Re: **Planning Commission Agenda 8/28/13, Item #8 Aptos High Athletic Field Supplemental Information**

**Project:** Aptos High School Athletic Field

**Response to Comments  
Received during Initial Study  
Circulation**

Exhibit A  
Page 1 of 2

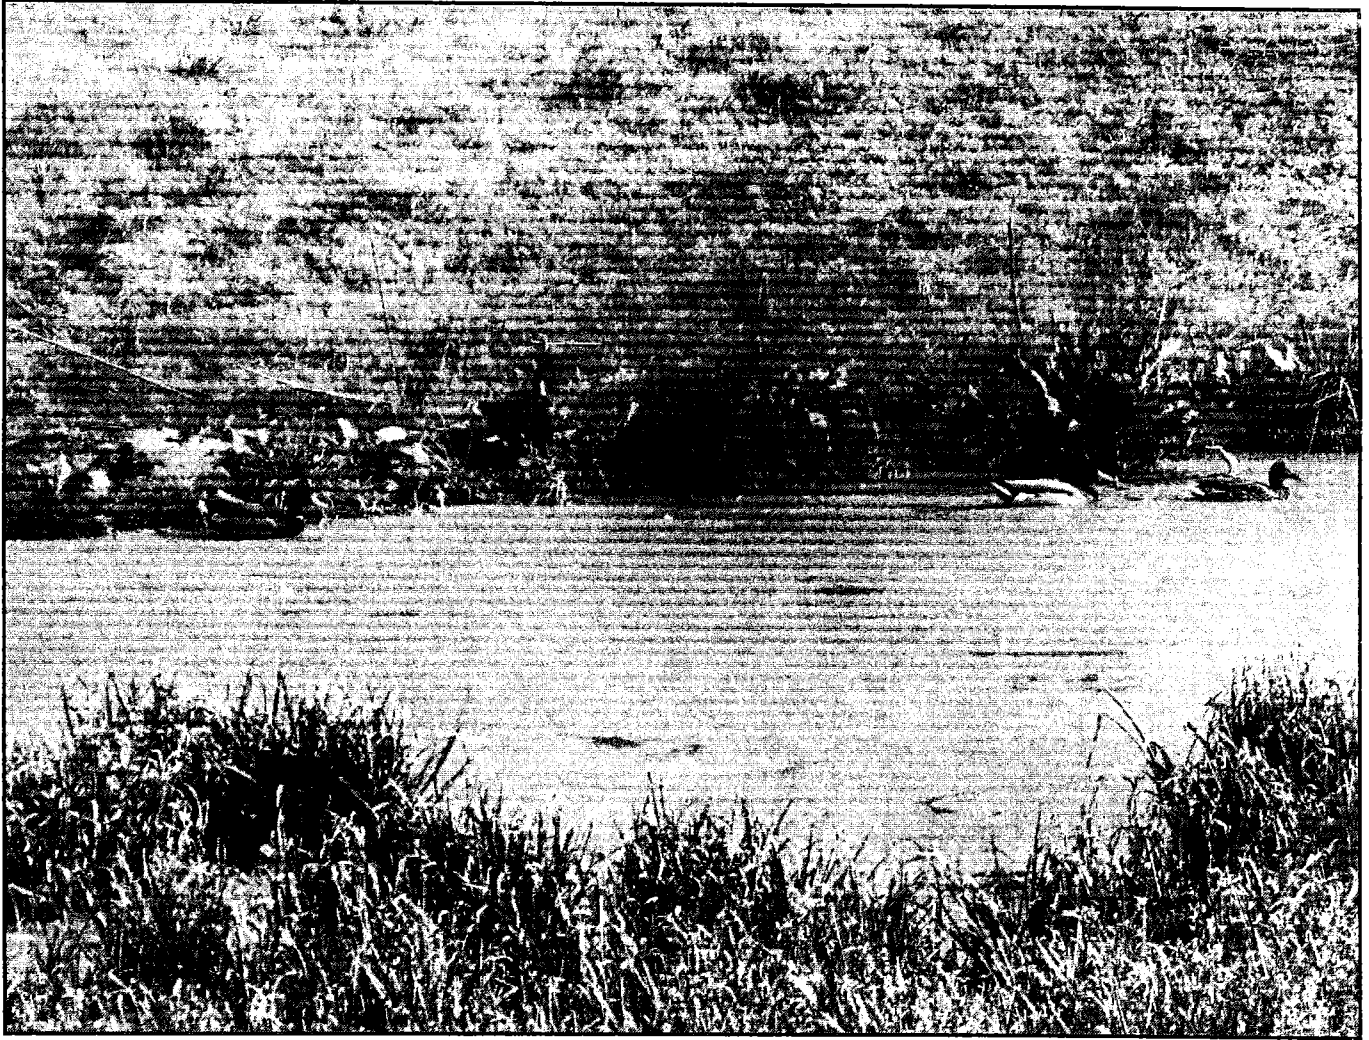
Just because a site is not mapped as containing a biologically sensitive habitat does not always mean no such habitat occurs on the site. Refer to the comment for Page 3; Paragraph 2 above and Exhibit A.

*Please refer to Response to Comment #3, above.*

**Page 16; Item C.4**

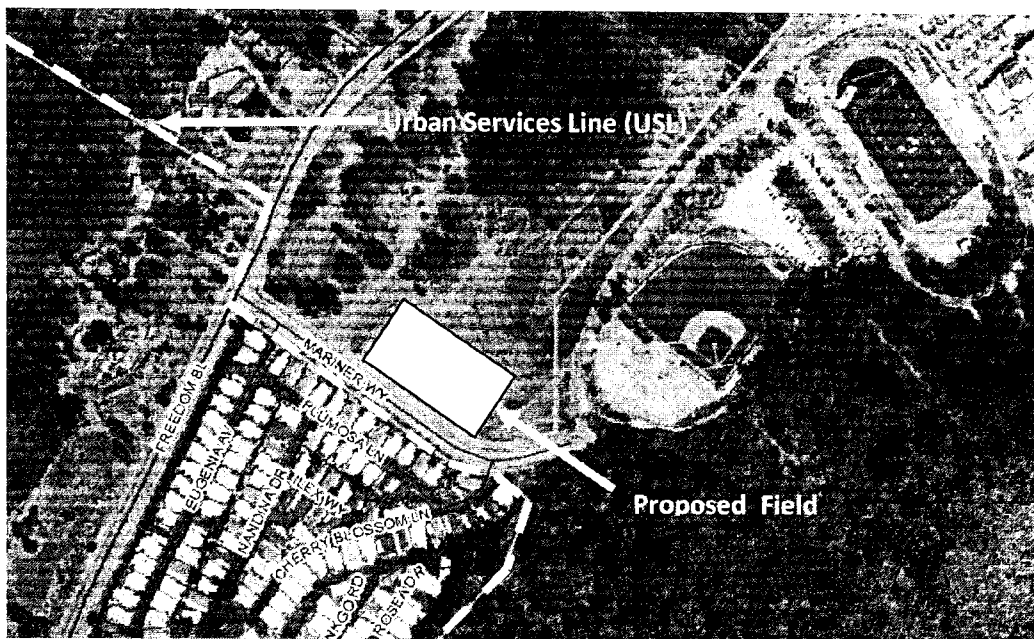
This comment wrongly identifies the project site as being located in an urban area. On the high school side of Freedom Blvd., the County’s Urban Services Line (USL) ends at the south edge of Mariner Way. On the opposite (west) side of Freedom Blvd, the USL ends a few feet north of the Mariner Way intersection. The Aptos Pines Mobile Home Park is within the USL, but the project site, Aptos High School campus and most rural residential properties on the west side of Freedom Blvd. are located beyond the USL and do not have most urban services. Properties on the west side of Freedom Blvd. that are within the USL are designated by the General Plan as “Rural Residential” land use and zoned “RA”, so they too are essentially rural properties.

Street lighting on this segment of Freedom Blvd. is limited to its intersections with Soquel Drive and Mariner Way. The proposed lighting described by Planning staff in this section of the Initial Study would not generate a substantial change in the nighttime environment if it is designed as true

pedestrian-oriented lighting that shines downward rather than outward on to other nearby properties. In addition, pedestrian lighting is placed on standards not exceeding two-feet in height. However, the project plans do not provide any lighting details. Therefore, the description of lighting in this section of the Initial Study is not substantiated by any facts. Absent any plans that show “low impact” lighting, this section of the Initial Study needs to provide performance standards to ensure future lighting will actually be “low impact” and not generate glares on nearby dwellings on the opposite side of Mariner Way. The conclusion for this issue needs to be changed in the Initial Study to “Less than Significant with Mitigation Incorporated” and a mitigation measure, such as performance standards for this lighting, needs to be included.

*outlined in the MOU adopted by PVUSD (Initial Study Attachment 8) the lighting proposed for the field is limited, stating “no stadium or other lighting for evening games/practices shall be installed and/or allowed”, and that in response to neighbor security concerns PVUSD will install “appropriate security lighting for the parking lot and adjacent walkways”. The resulting lighting plan for the proposed athletic field would be minimal; per verbal communications with PVUSD staff lighting will consist of an overhead motion-sensitive security light and bollard path lighting. As noted here, this lighting is similar in nature to existing light sources.*
